UNITED STATES PATENT AND TRADEMARK OFFICE

APPLICATION NO.	FILING DATE	FIRST NAMED INVENTOR	ATTORNEY DOCKET NO.	CONFIRMATION NO.
10/552,715	06/30/2006	Peter Schreiber	8071.004.PCUS00	6818
26474 7590 12/14/2007 NOVAK DRUCE DELUCA + QUIGG LLP 1300 EYE STREET NW SUITE 1000 WEST TOWER WASHINGTON, DC 20005			EXAMINER STAFIRA, MICHAEL PATRICK	
			ART UNIT 2886	PAPER NUMBER
			MAIL DATE 12/14/2007	DELIVERY MODE PAPER

Office Action Summary	Application No. 10/552,715	Applicant(s) SCHREIBER ET AL.	
	Examiner Michael P. Stafira	Art Unit 2886

FIG. 2

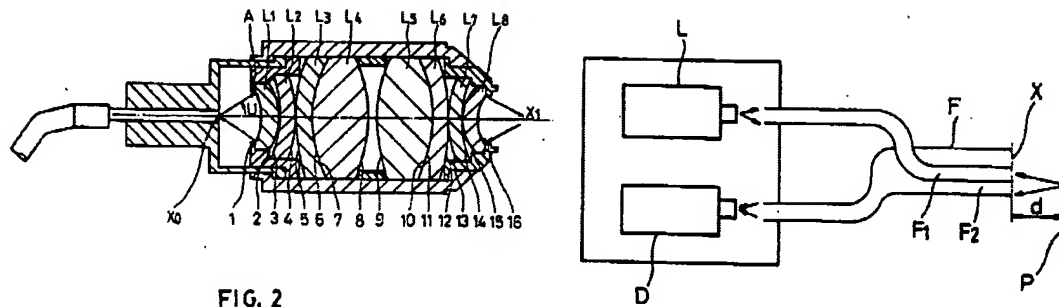
Chao et al. ('515) discloses determining the distance of a reflecting surface (Fig. 4a, Ref. P) onto which light from a light source (Fig. 4a, Ref. L) is directed via a first optical fiber (Fig. 2, Ref. X0) and from which reflected light passes onto at least one statically arranged optical detector (Fig. 4a, Ref. D) via the first optical fiber or at least one further optical fiber (See Fig. 4a), characterized in that the light runs on to the reflecting surface (Fig. 4a, Ref. P) and from the reflecting surface (Fig. 4a, Ref. P) via at least one optical element (Fig. 2, Ref. L8), collimating in the direction of the reflecting surface (Fig. 2, Ref. L4, L5), and at least two optical elements (Fig. 2, Ref. L6, L7) that focus in the direction of the reflecting surface ((Fig. 4a, Ref. P) and whose optical axes are aligned parallel to the optical axis of the collimating optical element (Fig. 2, Ref. L4, L5) and are arranged at prescribed spacing's from one another (See Fig. 2).

Chao et al. ('515) discloses the focusing optical elements (Fig. 2, Ref. L6, L7) are arranged equidistantly from one another (See Fig. 2).

Chao et al. ('515) further discloses the focusing optical elements (Fig. 2, Ref. L6, L7) are arranged at a constant distance from the collimating optical element (Fig. 2, Ref. L4, L5).

Chao et al. ('515) further discloses the convex surfaces of the focusing optical elements (Fig. 2, Ref. L6, L7) are aspherically curved (See Fig. 2).

The reference of Chao et al. ('515) further discloses that the collimating optical element (Fig. 2, Ref. L4, L5) is a plano-convex optical lens (See Fig. 2).

Chao et al. ('515) further discloses that the convex surface of the collimating optical element (Fig. 2, Ref. L6, L7) is aspherically curved (See Fig. 2).

Chao et al. ('515) discloses the end face(s) of the first optical fiber and/or the at least one further optical fiber (Fig. 2, Ref. X0) is/are aligned orthogonal to the optical axis of the collimating optical element (Fig. 2, Ref. L4, L5).

Chao et al. ('515) discloses free spaces are present between focusing optical elements (Fig. 2, Ref. L6, L7).
